**TOWN OF NEWBURGH
PLANNING BOARD
TECHNICAL REVIEW COMMENTS**

PROJECT: DARRIGO SOLAR FARM
PROJECT NO.: 19-24
PROJECT LOCATION: SECTION 86, BLOCK 1, LOT 96
REVIEW DATE: 26 FEBRUARY 2021
MEETING DATE: 4 MARCH 2021
PROJECT REPRESENTATIVE: ARDEN CONSULTING- MICHAEL MORGANTE, P.E.

Response to Comments

PATTON ROAD ENTRY

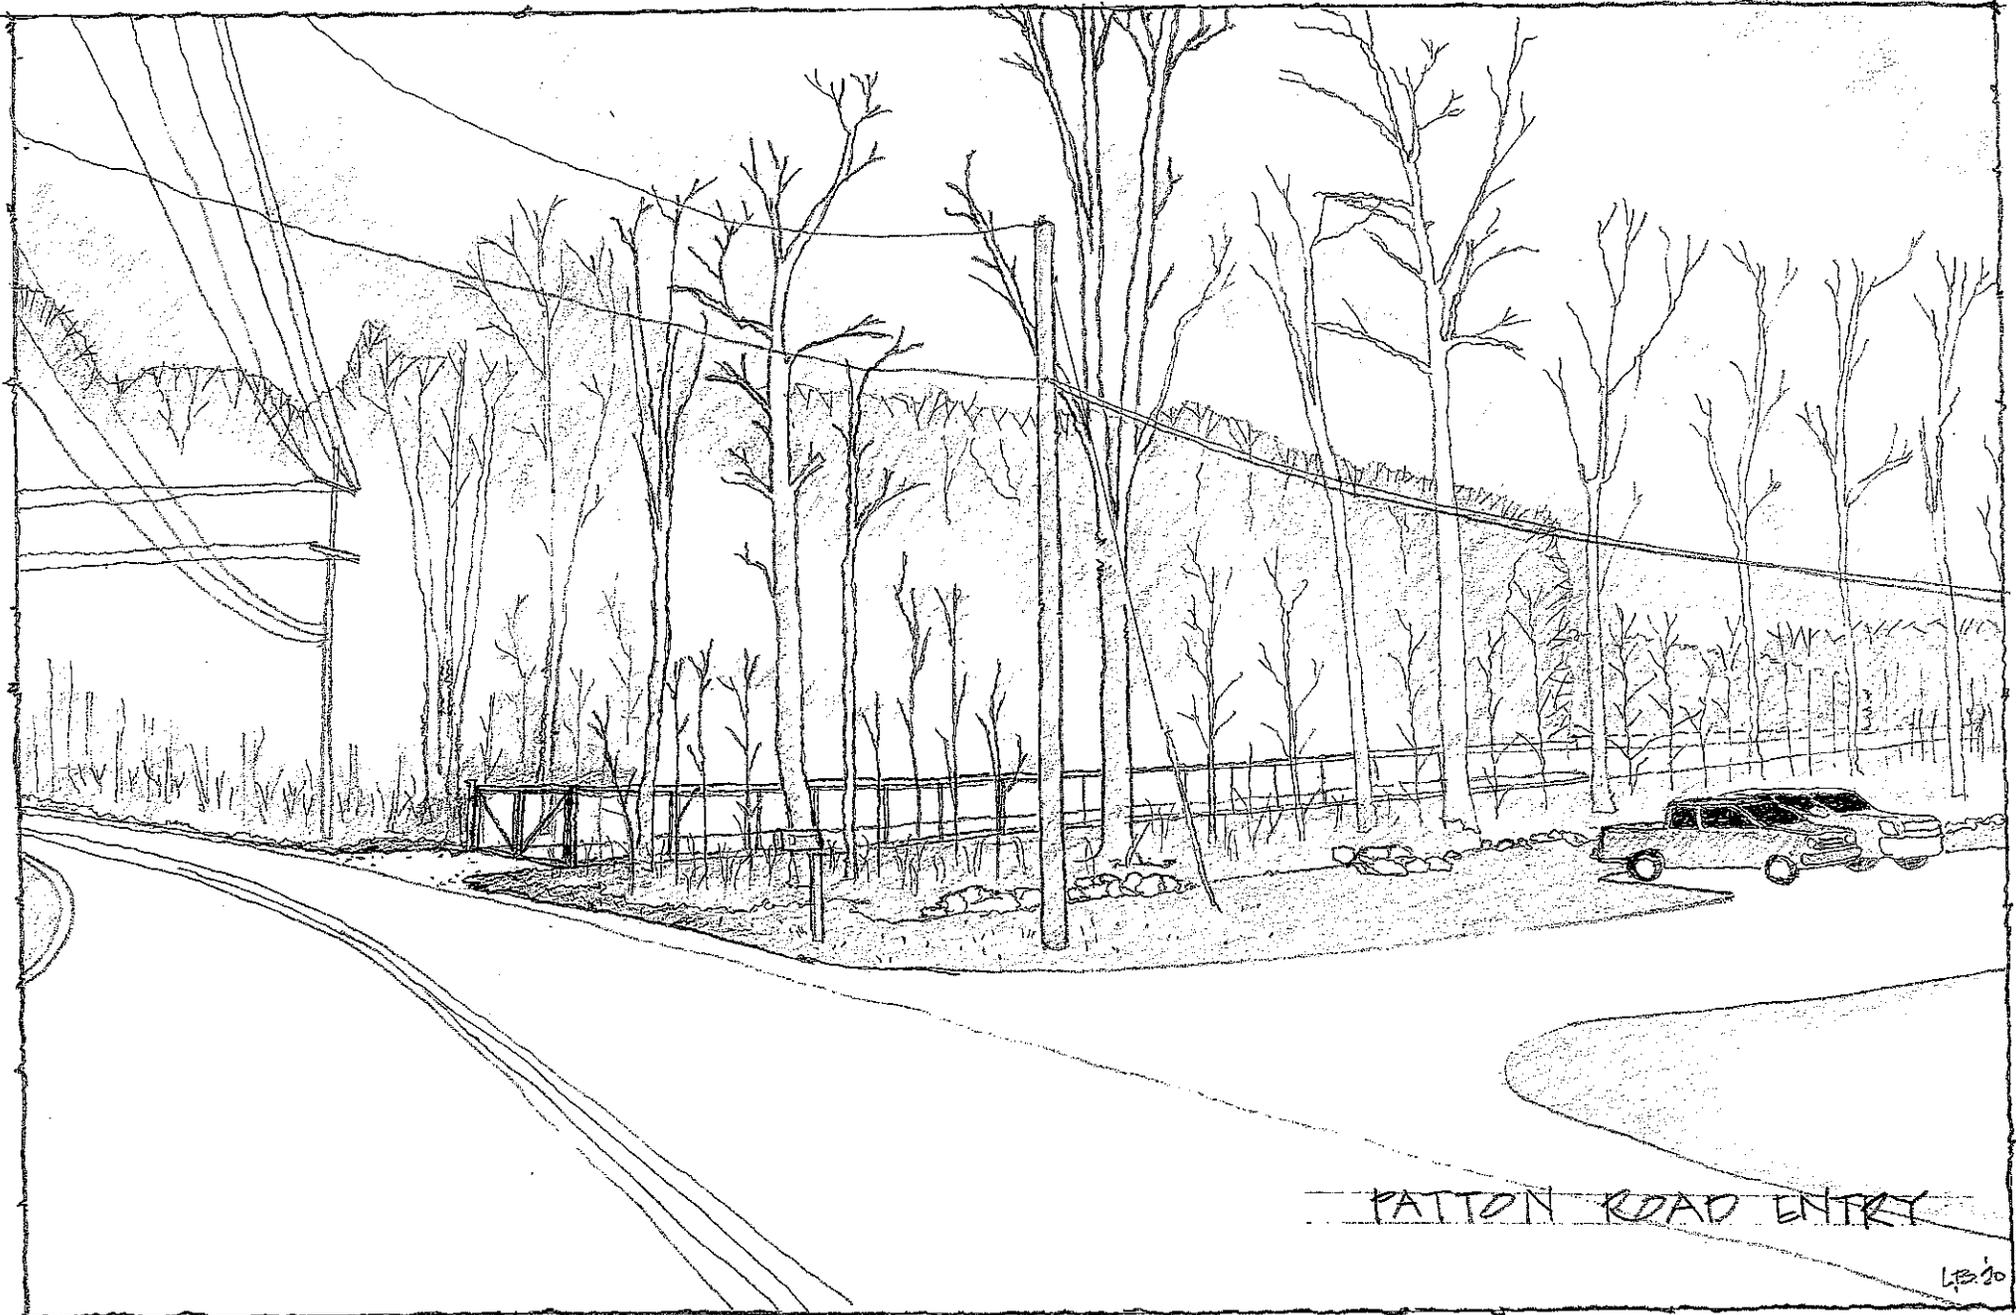
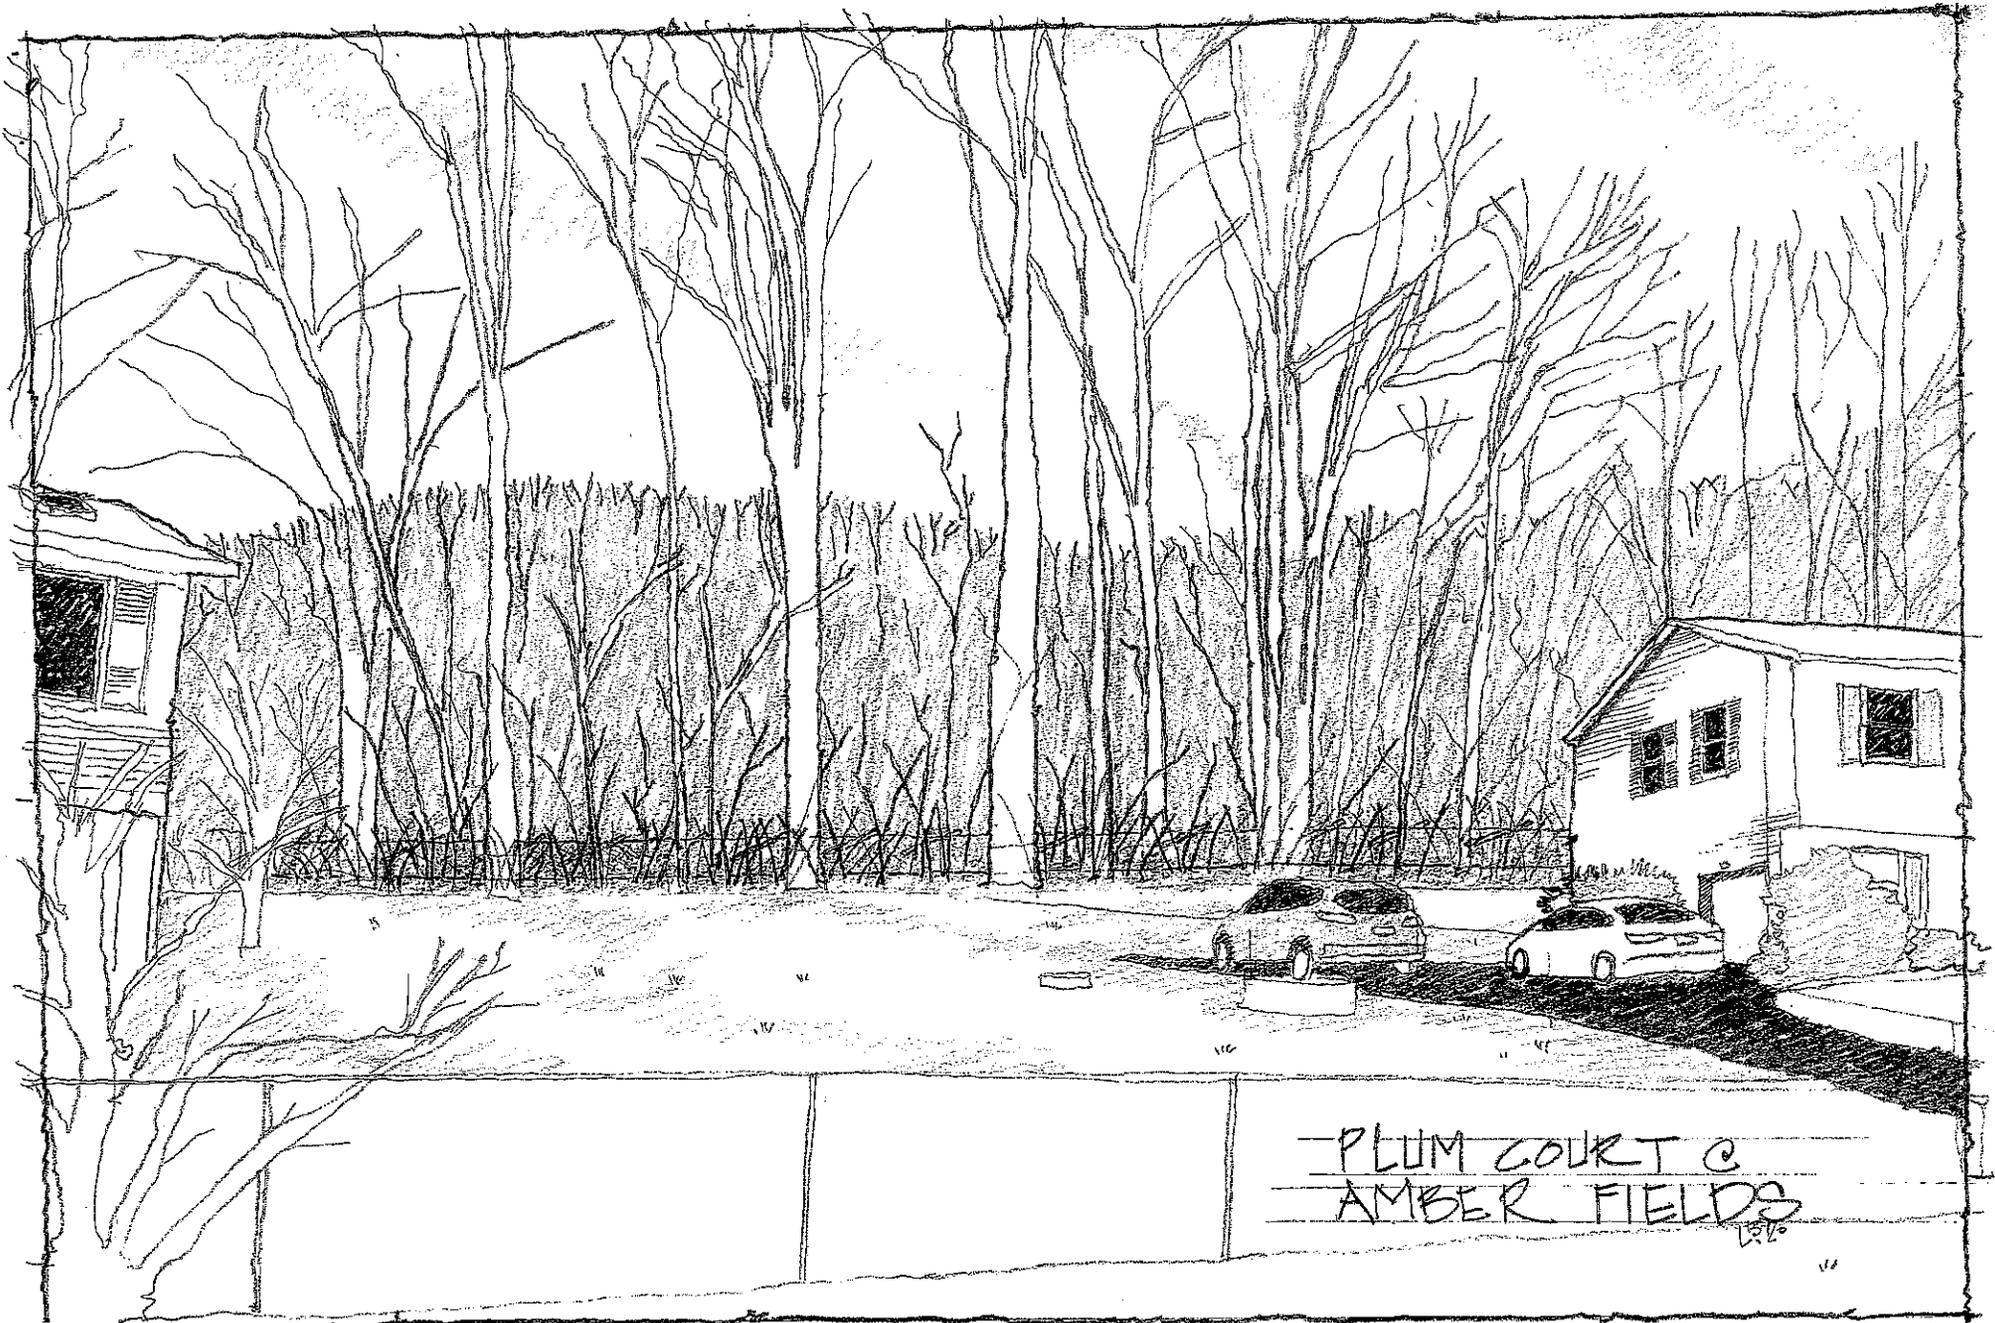
12. The Planning Board previously requested some visual simulations of the project from Amber Fields neighborhood / Monarch Drive / Meadow Hill Road / Patton Road and Lakeside Road. These visual assessments should be provided.
Drawings attached as exhibit H.

8. Viewshed studies of the 84 buffer, Lakeside, Meadow, Patton and Amber Fields view renderings.
See attached as Exhibit H.
9. Clean up proposal in writing for the Farm and Supply Yard.
See Attached as Exhibit J.
10. Landscape maintenance plan for the next three years for watering, feeding and care to insure its survival.
See attached as Exhibit K.
